CITY OF WEST LAKE HILLS, TEXAS
NOTICE OF ZONING & PLANNING COMMISSION (ZAPCO) REGULAR MEETING
Wednesday, October 21, 2020 at 6:30 PM

CITY OF WEST LAKE HILLS, TEXAS
MINUTES OF A ZONING & PLANNING COMMISSION (ZAPCO) REGULAR MEETING
Wednesday, September 16, 2020 at 6:30 PM

Doucet & Associates, Inc. (Doucet), is pleased to submit this response letter to our September 29, 2020 engineering drainage report documenting the analysis of a partial easement release located at 2 Downie Place in West Lake Hills, Texas. Our response to Comments 3-8 are as follows in blue text.

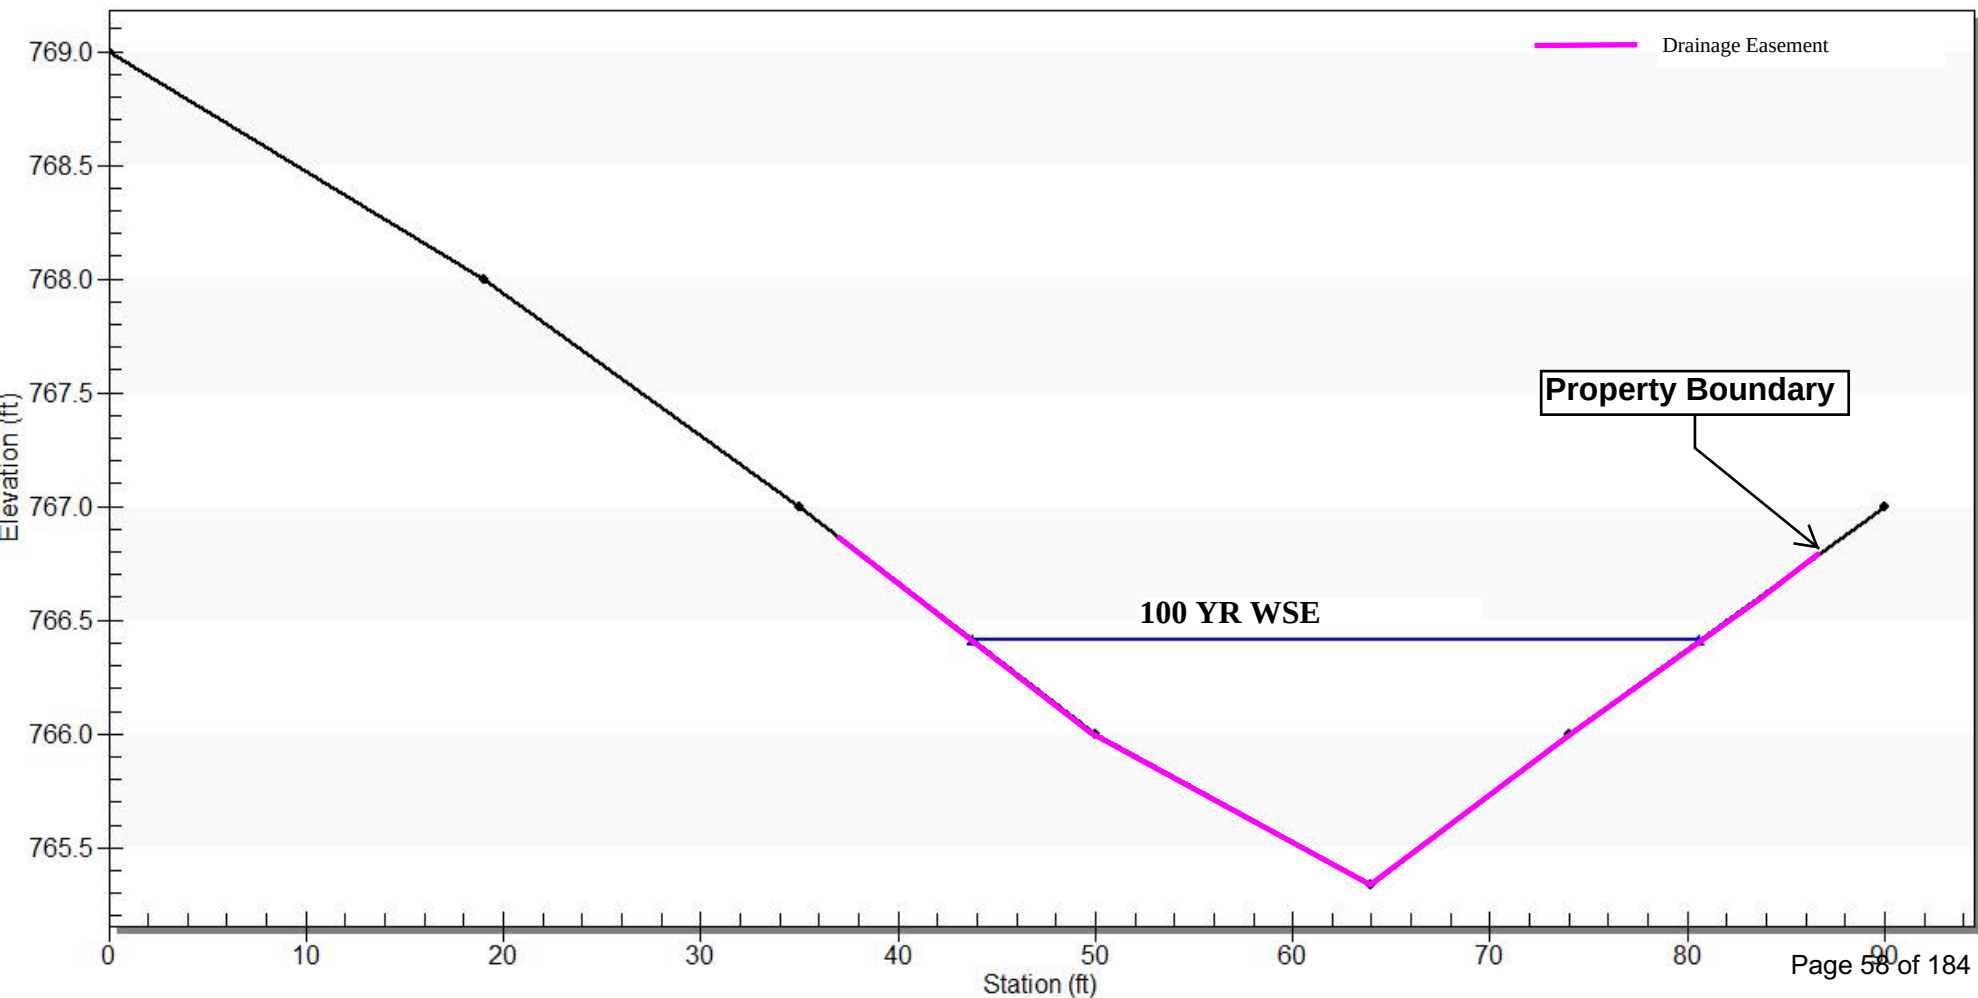
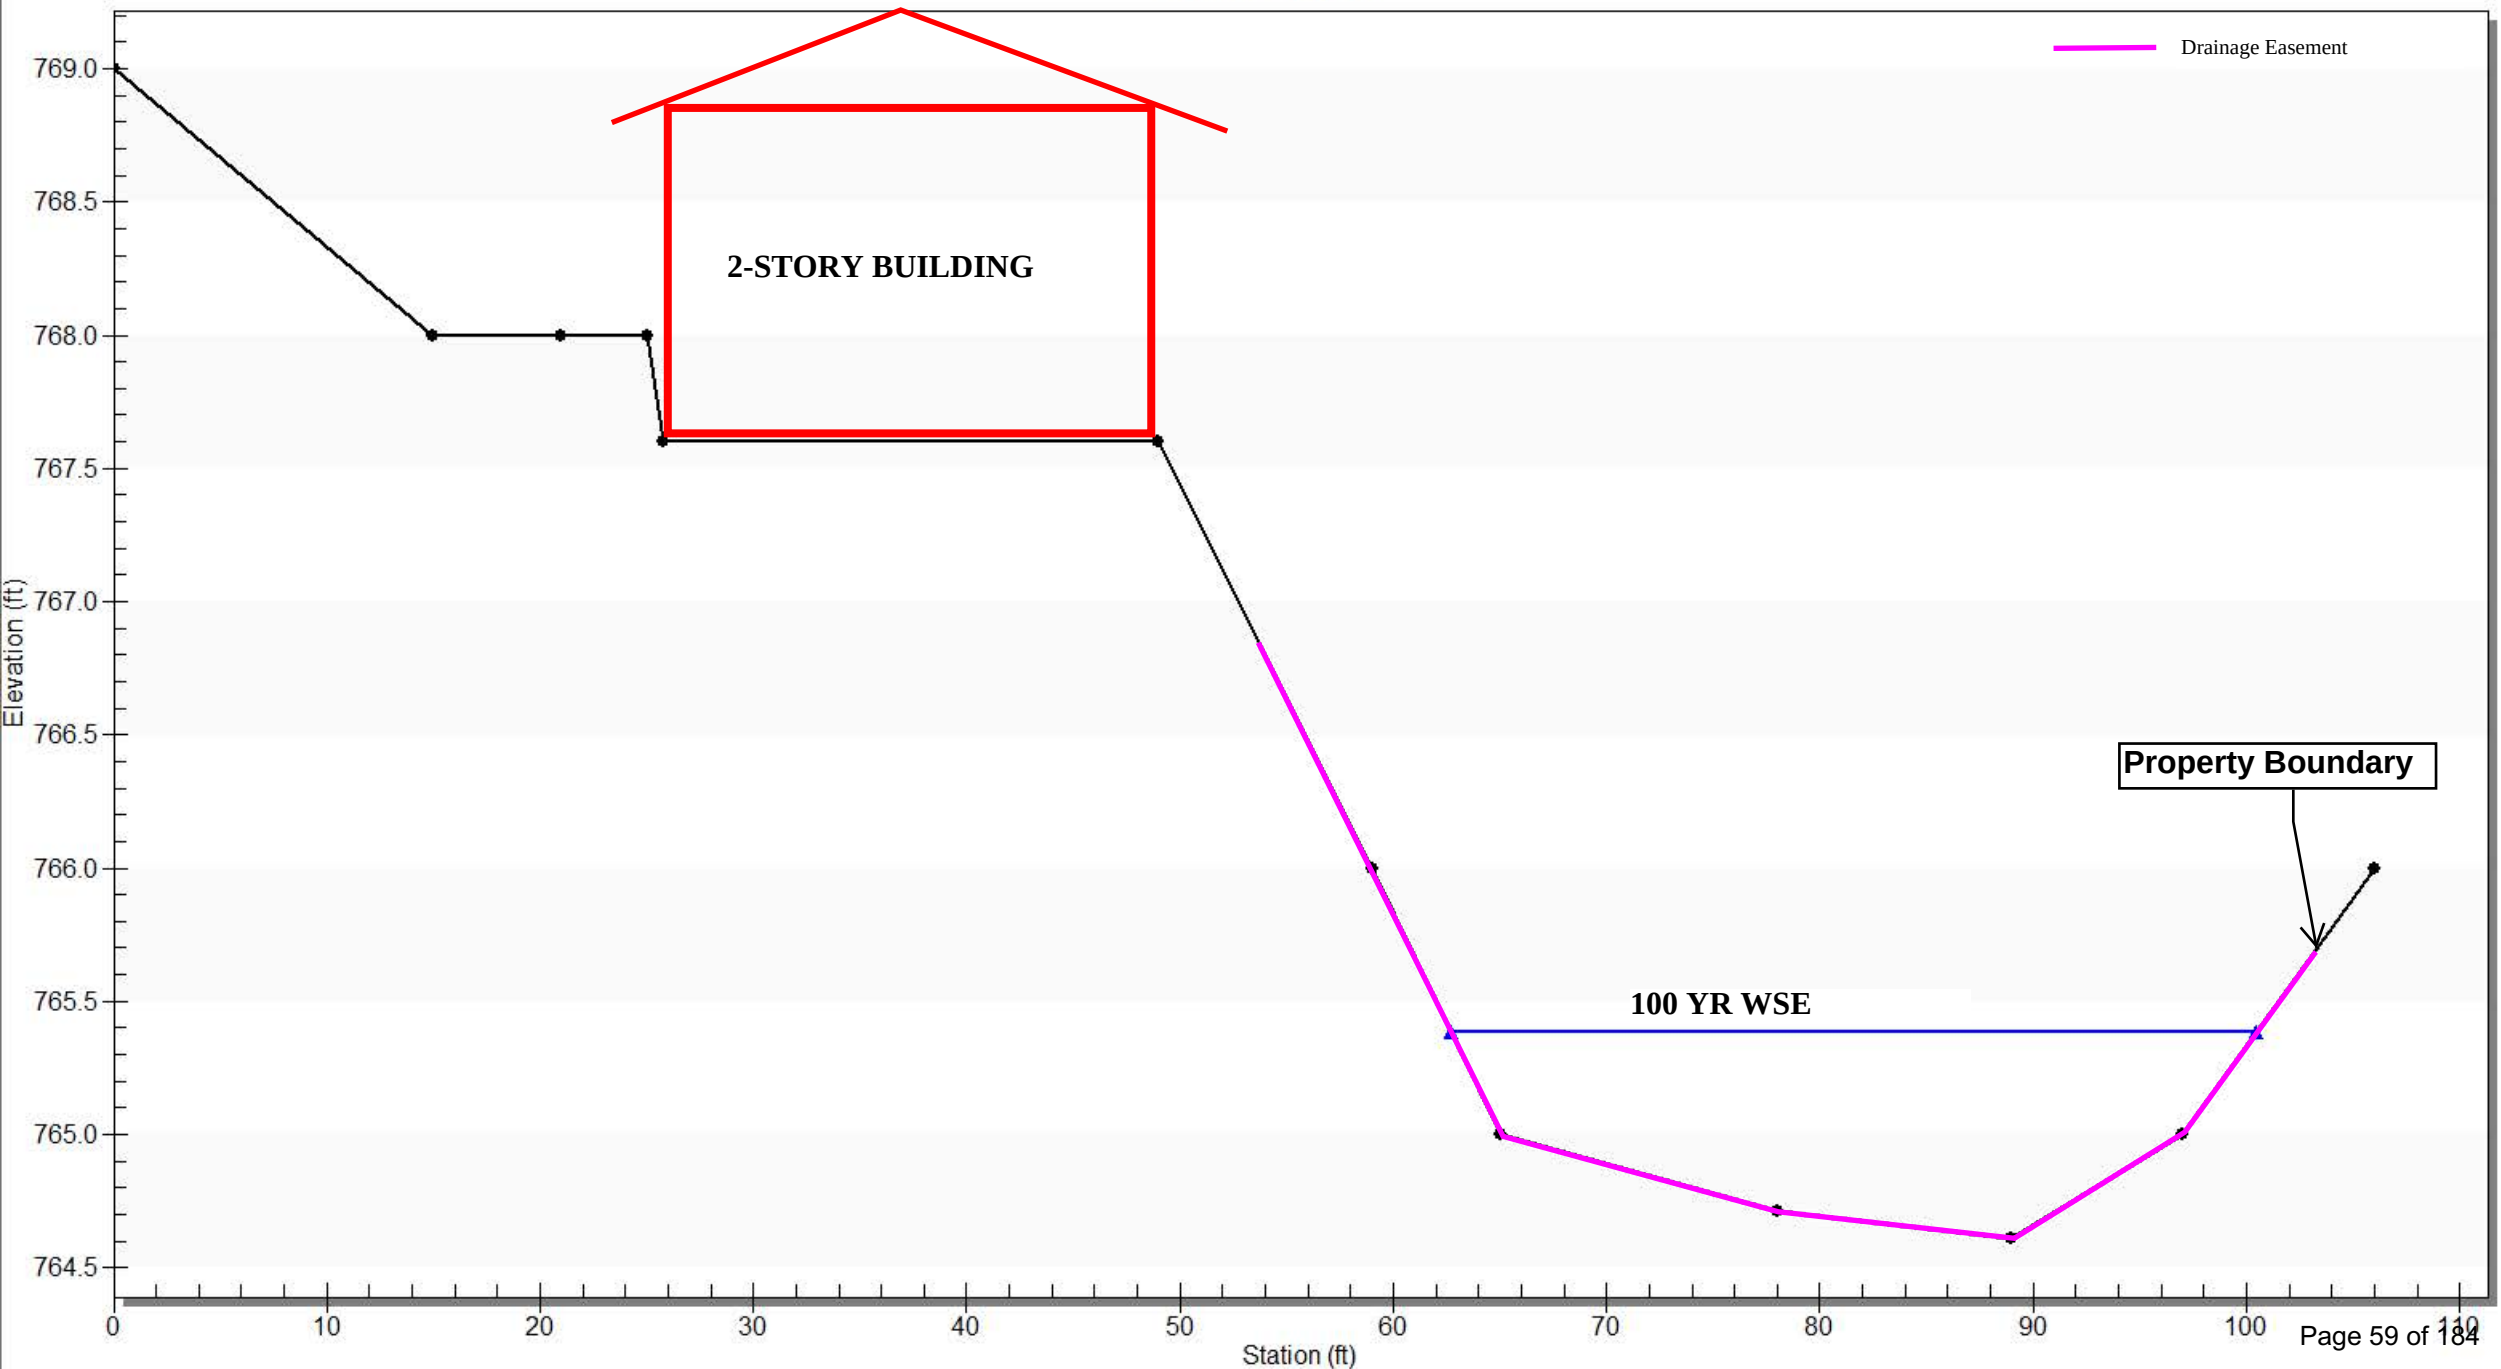
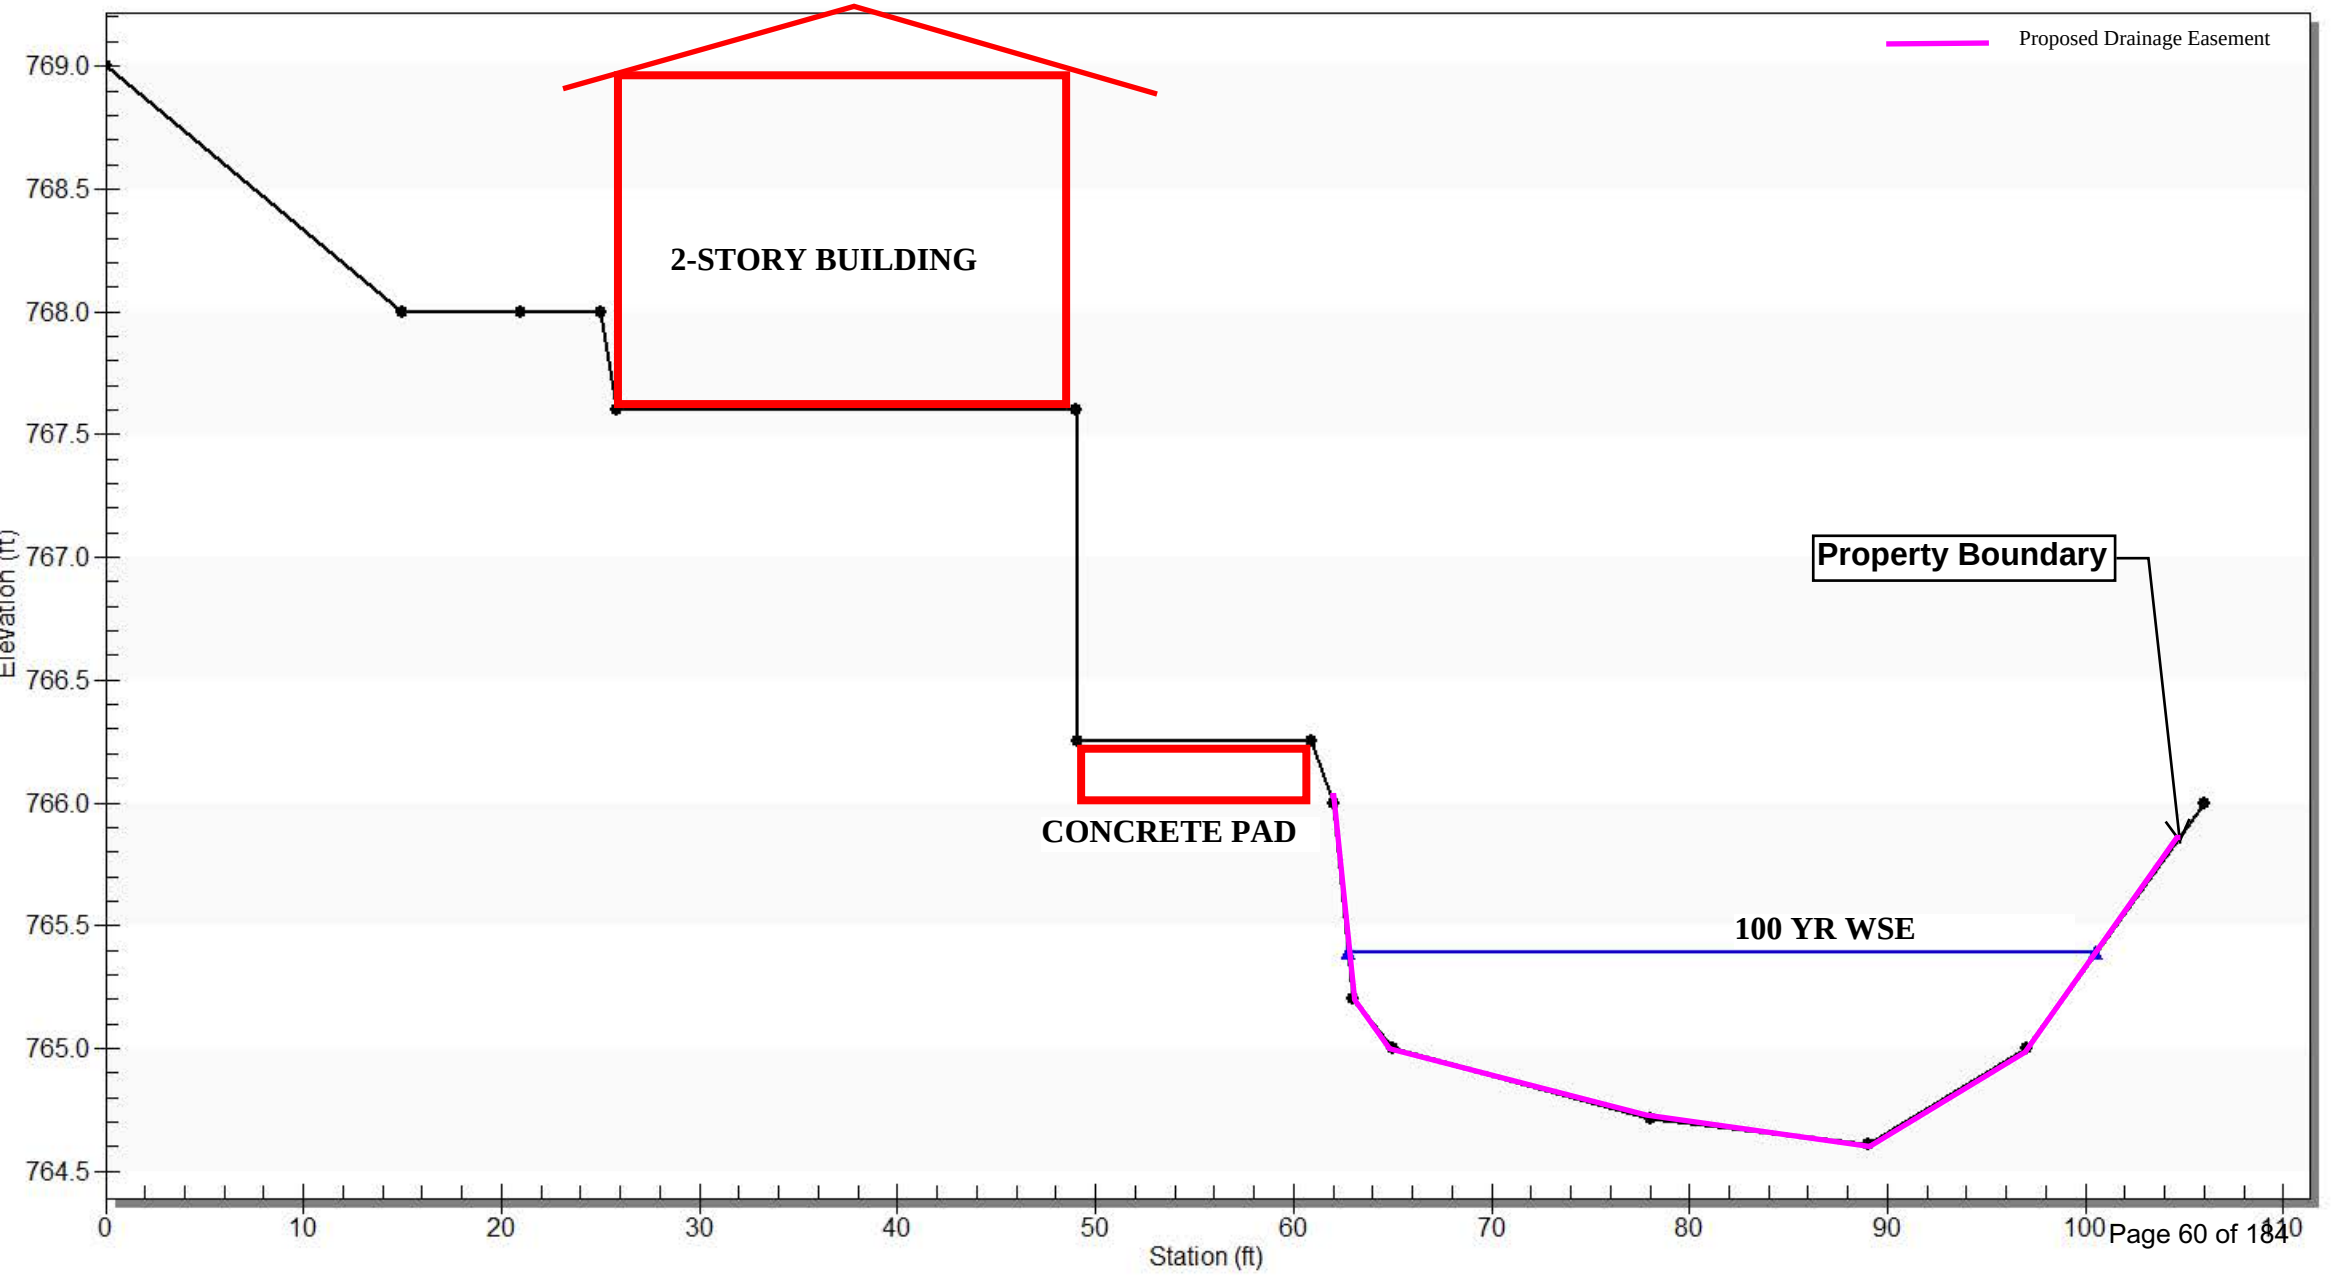
3-C1) Please show property line, existing, and proposed easement line in the cross section to verify overtopping elevations.

7-C1) Please show property line, existing easement line, and proposed easement line in the cross sections.

Response: Easement lines and property boundary has been added to cross sections.

Response: Easement lines and property boundary has been added to cross sections.
